BCA Assessment Report

Design Development Report
World Class End of Life Program
Tamworth Hospital

Prepared for:
Health Infrastructure

Revision 2
26 March 2025
Reference: N240096

Figure 2: Required fire separation of the proposed Palliative Care Unit from the existing building and Linkway on the Ground Floor

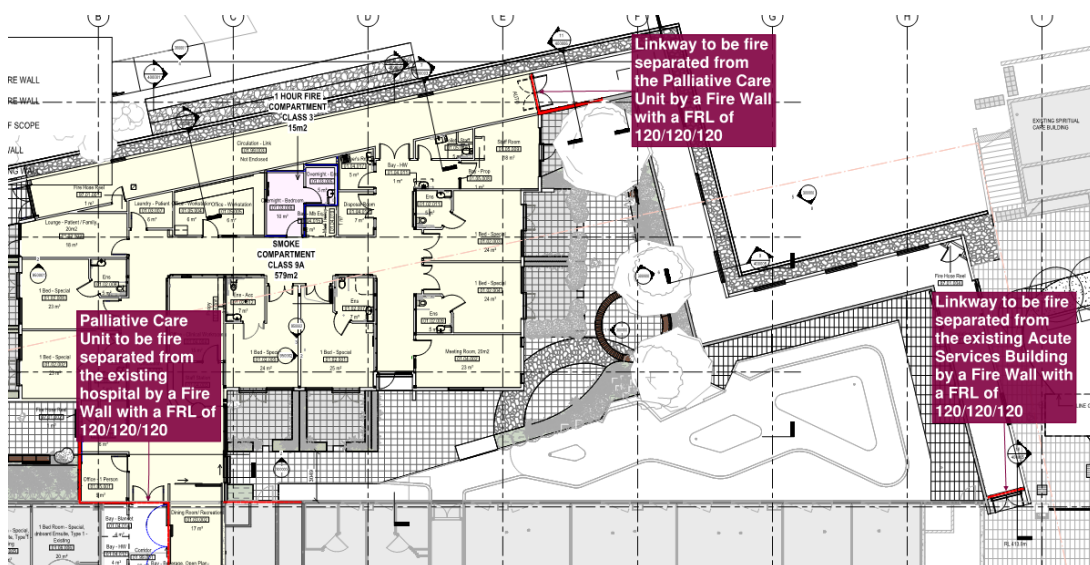
- + The proposed Palliative Care extension will be required to be fire separated from the existing building by a fire wall with an FRL of 120/120/120 separating internal parts of the building as detailed in the figure below.
- + The enclosed linkway will be required to be fire separated from both the existing hospital building along with the proposed palliative care unit by a fire wall with an FRL of 120/120/120 as detailed in the figure below.

Figure 3: Excessive smoke compartment contained within the Palliative Care Extension

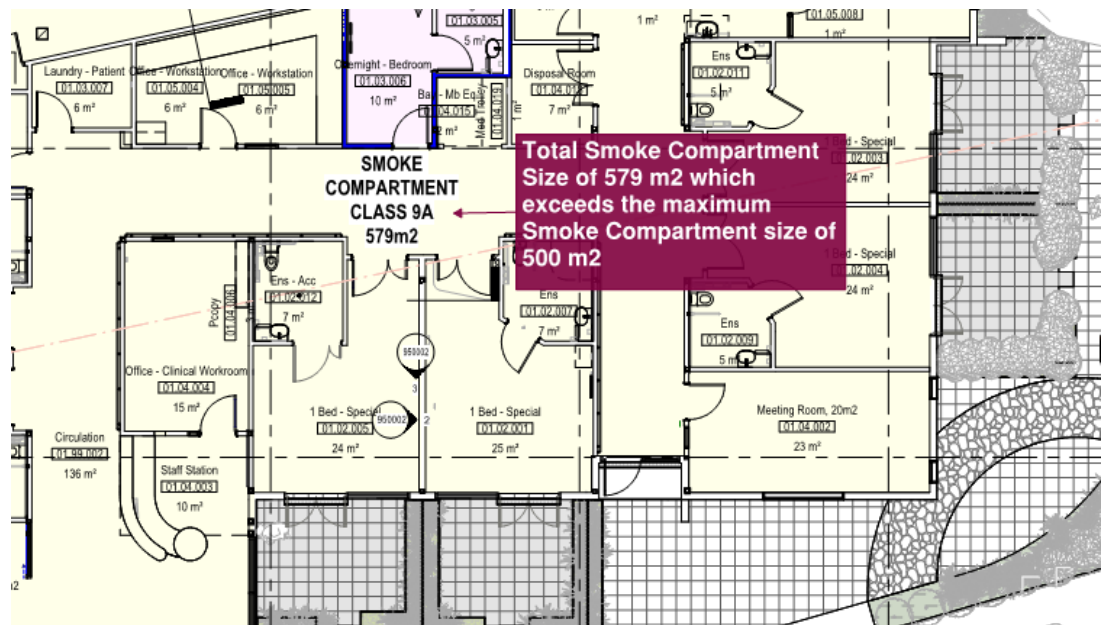
It is noted that the Smoke Compartment of the extensions contains a Smoke Compartment with a total size of 579 m² as detailed in the figure below.

Figure 4: Length of public serving the overnight room proposed to be subject of a fire engineering assessment

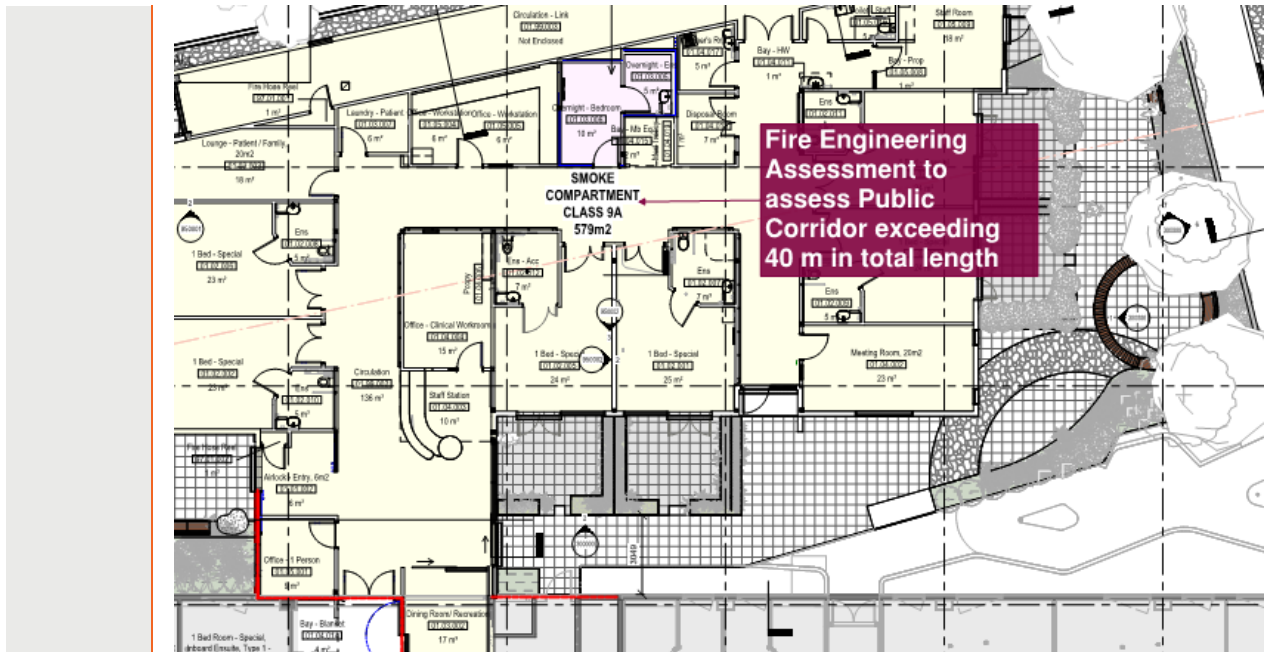
Consistent with the proposed Performance Solution assessment identified to be undertaken as detailed in Clause C4D12 below, the requirement for a corridor length not exceeding 40 m in length without smoke separation will be proposed to be addressed as part of a Fire Engineering Assessment noting that the IPU will be subject to smoke compartmentation being a Class 9a health care building.

Figure 6: Locations of exposure between fire compartments between the proposed palliative care unit and the existing building and the linkway

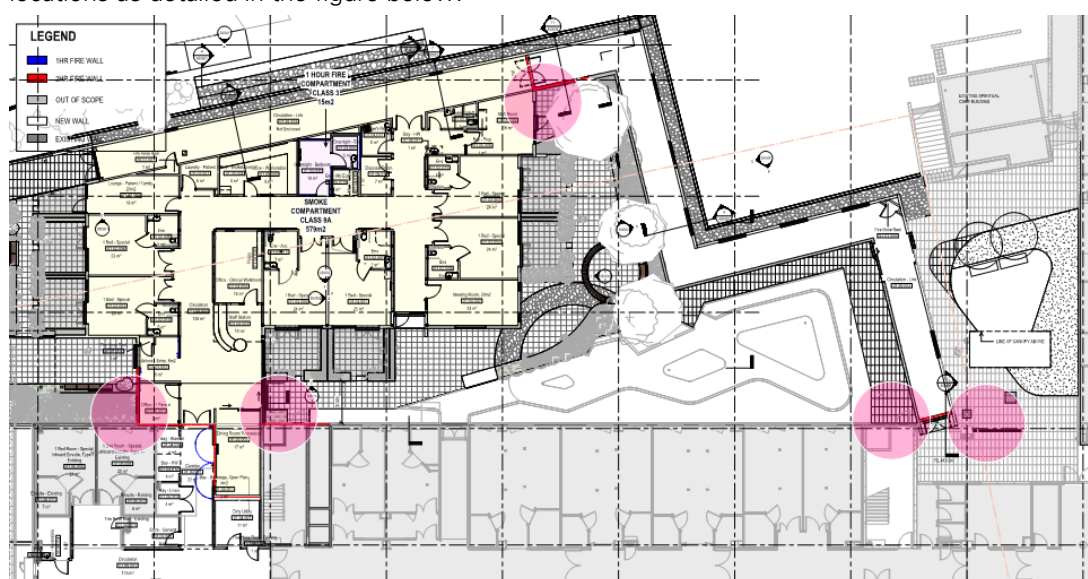
Based on the proposed design, exposure between fire compartment occurs in the following locations as detailed in the figure below.

Figure No. 7: Horizontal exit doors that require a minimum FRL of -/120/30

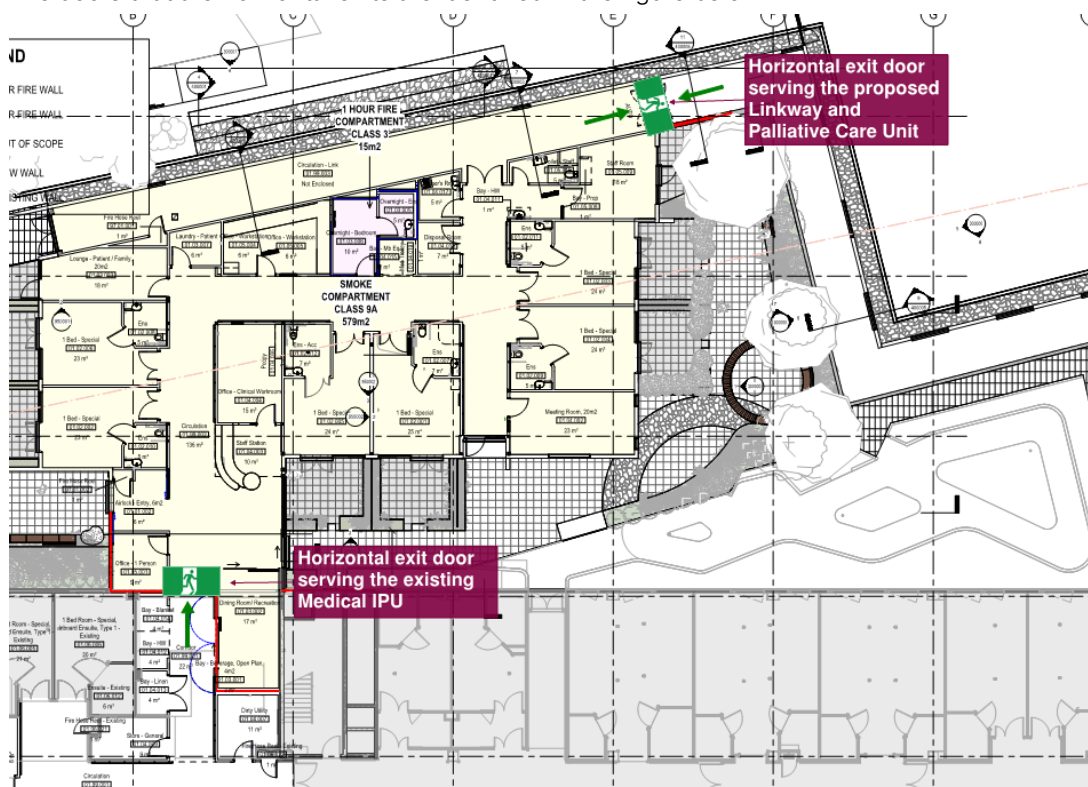
The doors that are horizontal exits are identified in the figure below.

Figure No. 9: Overnight room located within Palliative Care to be fire separated from the remainder of the floor

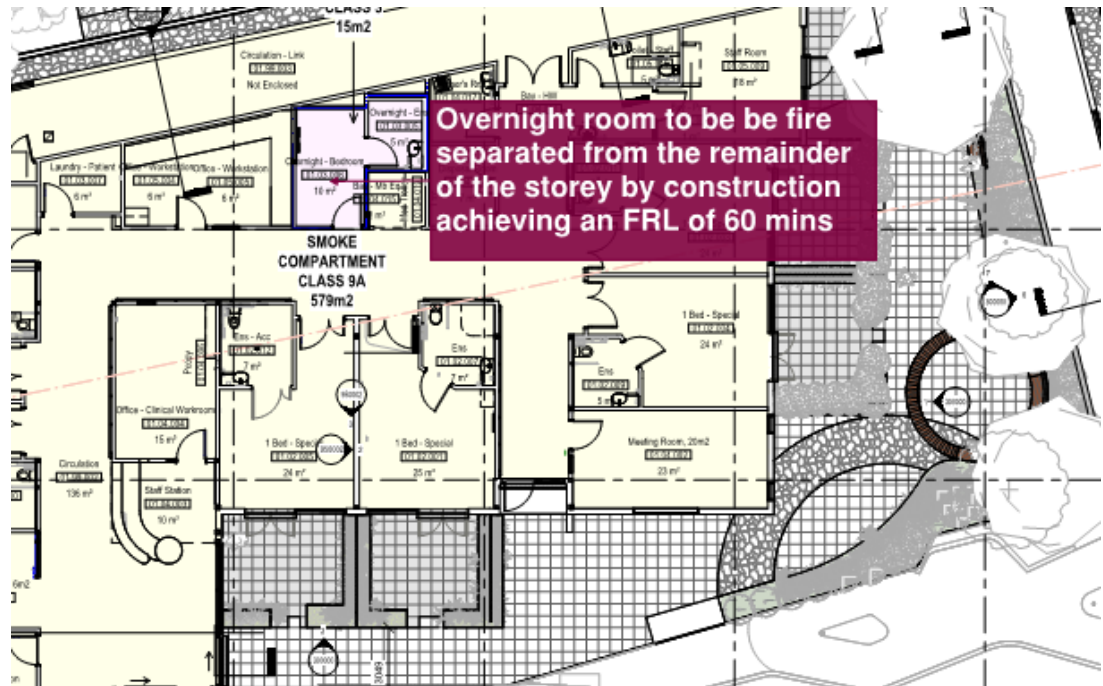
The walls bounding the overnight room are required to extend to the underside of the non-combustible roof sheeting and except for roof battens with dimensions of 75 mm x 50 mm or less or sarking type material, the fire rated walls must not be crossed by timber or other combustible building elements.

Figure No. 10: Fire safety door located in the Linkway to be addressed as part of FER if it is not dual swing

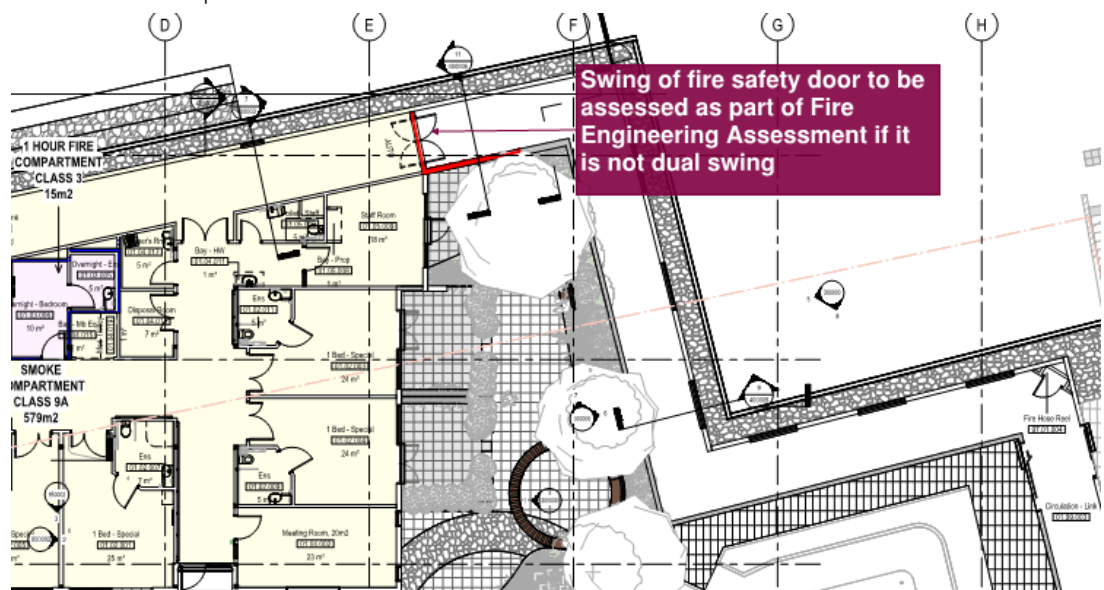
The fire safety door within the Linkway is required to swing in both directions. If the fire safety door is not dual swing, then the swing of the door against the direction of egress will be required assessed as part of a Fire Engineering Performance Assessment to be undertaken by the appointed Fire Safety Engineer in order to demonstrate compliance with the nominated Performance Requirements of the BCA.

Figure 12: Locations of extended travel distance from the proposed palliative care unit

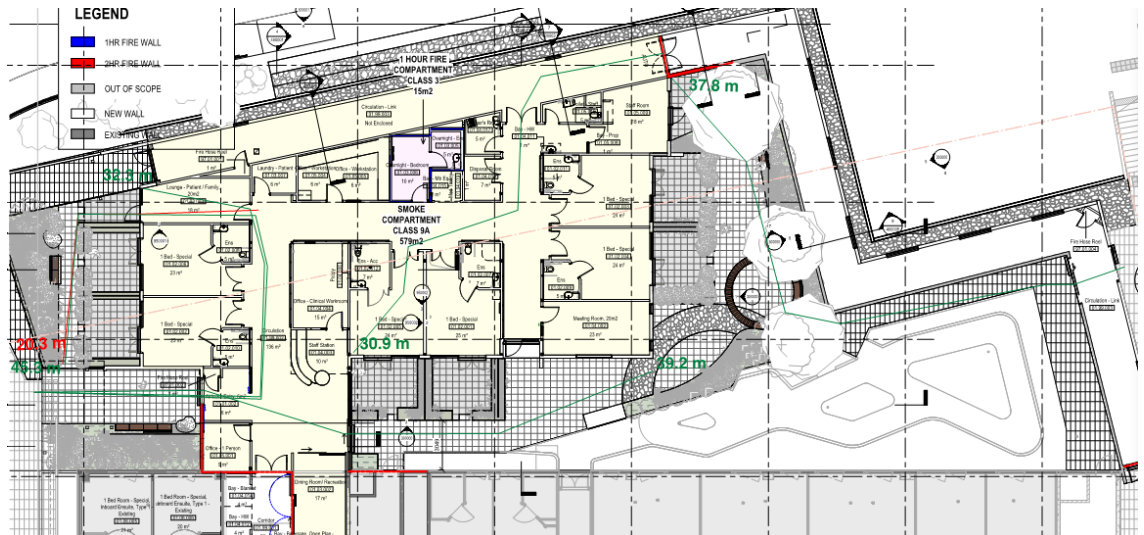
The extended travel distances are detailed in the figure below.

Figure 13: Locations of extended travel distance from the proposed palliative care unit

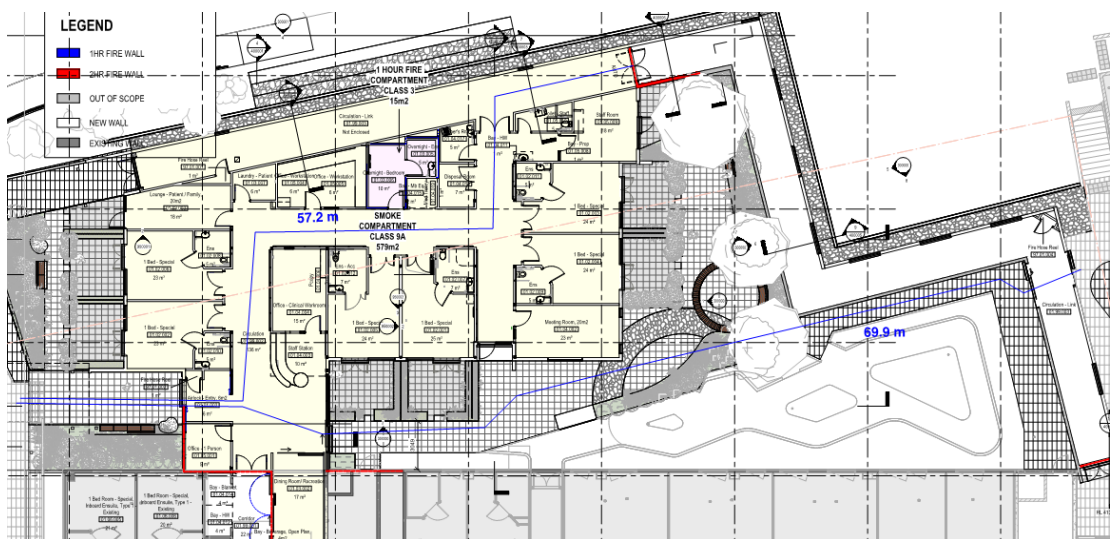
The extended travel distances are detailed in the figure below.

Figure 15: Alternative paths of egress from existing Fire Stair to be further reviewed with the Fire Safety Engineer

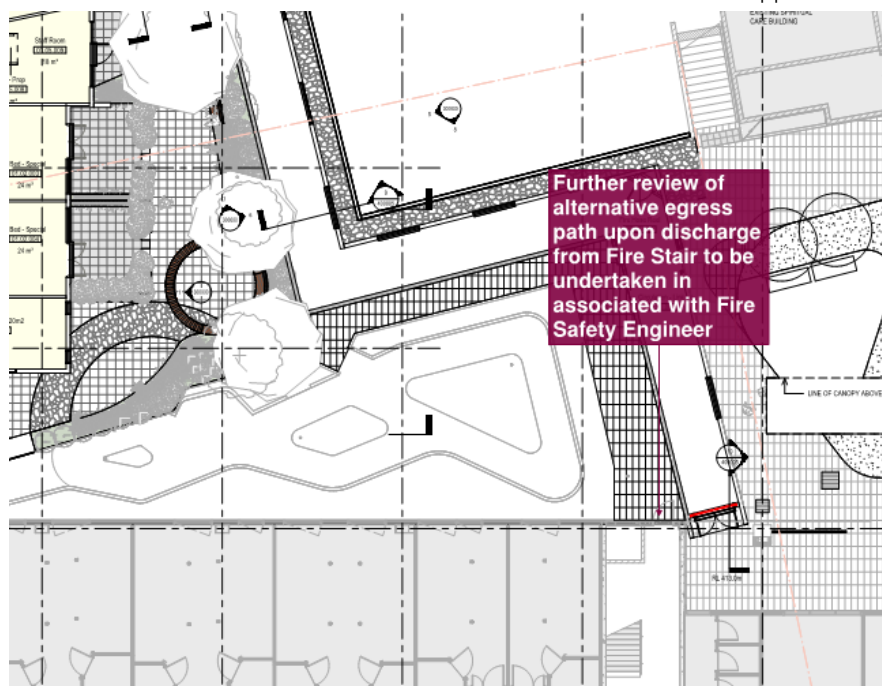
Note: Further review needs to be undertaken of the alternative egress path from the existing Fire Stair detailed below between Grids H & I in consultation with the appointed Fire Safety Engineer.

Figure 18: Exit discharge from enclosed linkway via covered walkway

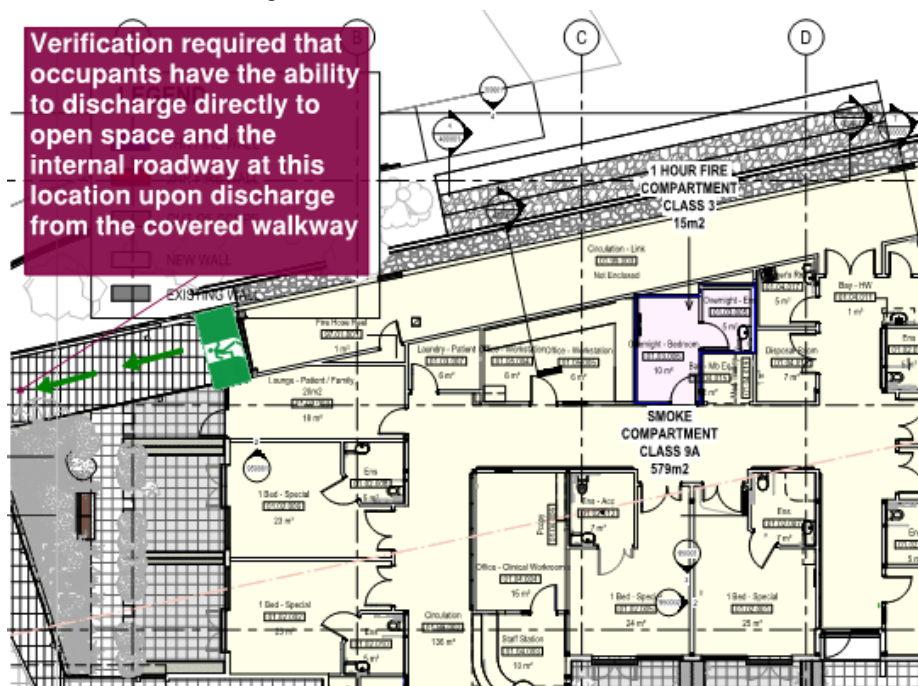
In relation to discharge from the exit serving the linkway as detailed in the figure below, verification is required that occupants reach open space once discharging beyond the covered new unenclosed link as detailed in the figure below.

Figure No. 20: Modified egress arrangement where travel via the horizontal exit serving Fire Compartment A has been impacted

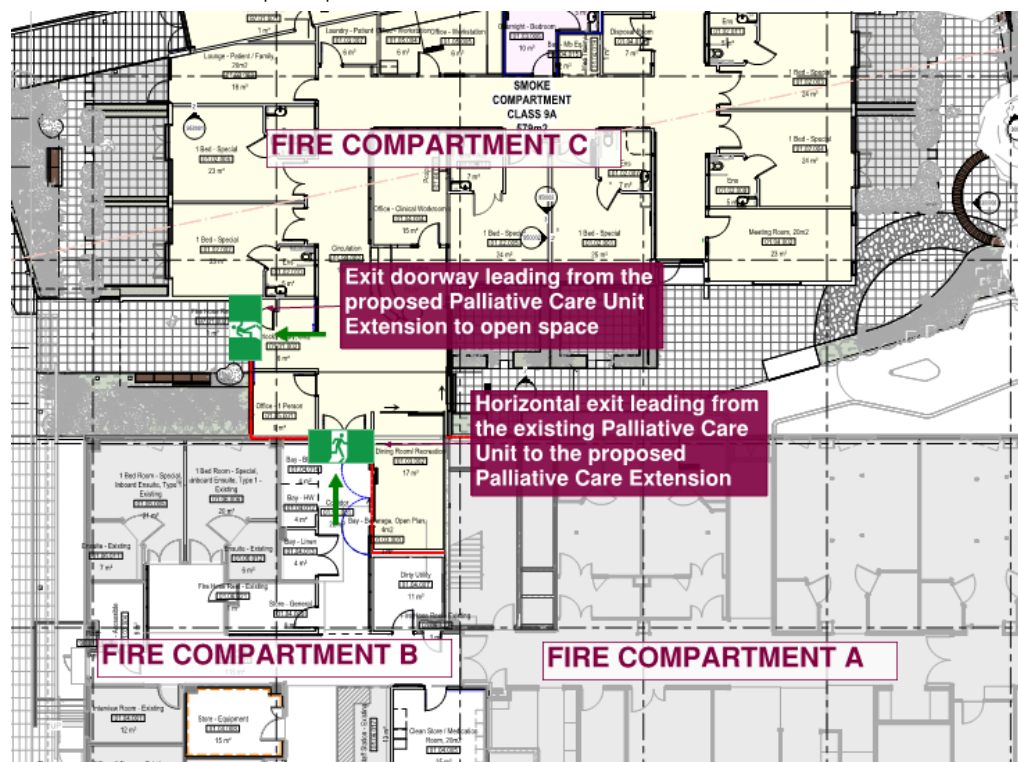
As a result of the proposed works, occupants egressing from Fire Compartment A discharge into Fire Compartment B which is no longer provided with an exit direct to open space, with occupants instead having to egress via a further horizontal exit into Fire Compartment C prior to be provided with an exit direct to open space.

Figure No. 26: Sliding door contained within patient care area

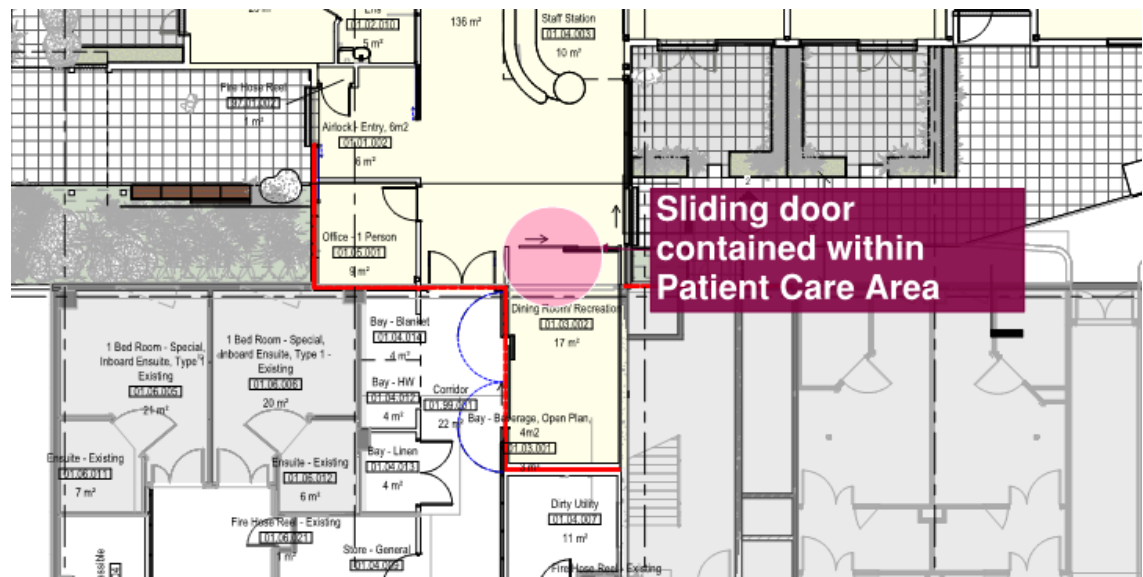
The Design Development Architectural documentation indicates the provision of a sliding door to the Dining and Recreation Room which is proposed to be refurbished as part of the works within the existing Palliative Care Unit as detailed in the figure below.

Figure No. 27: Verification required as to proposed doorway located within the fire wall

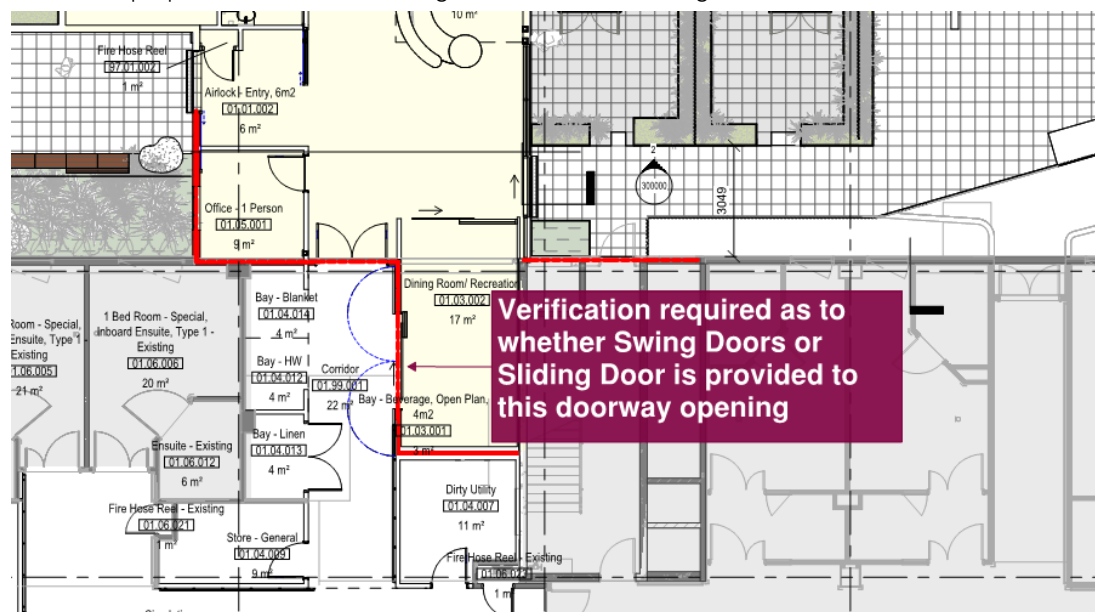
Verification is required to be provided that the doors detailed in the figure below which is located within the proposed fire wall are swing doors and not a sliding door.

Figure No. 28: Horizontal exit door located within the Linkway required to be addressed as part of Fire Engineering Assessment if it does not swing in both directions

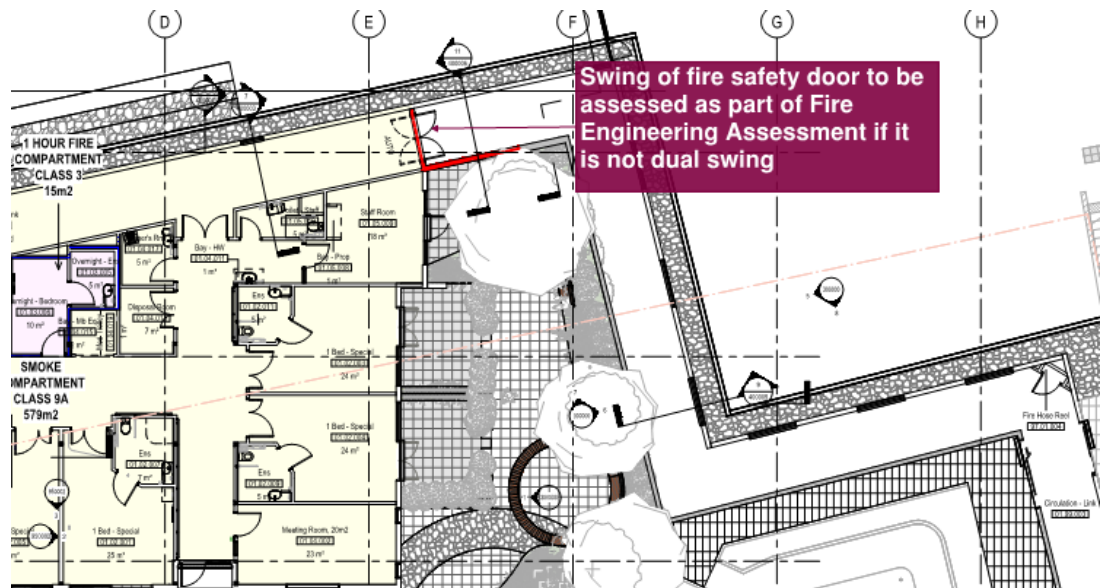
The horizontal exit within the Linkway is required to serve as a horizontal exit in both directions. If the horizontal exit door is not dual swing, then the swing of the door against the direction of egress will be required assessed as part of a Fire Engineering Performance Assessment to be undertaken by the appointed Fire Safety Engineer in order to demonstrate compliance with the nominated Performance Requirements of the BCA.
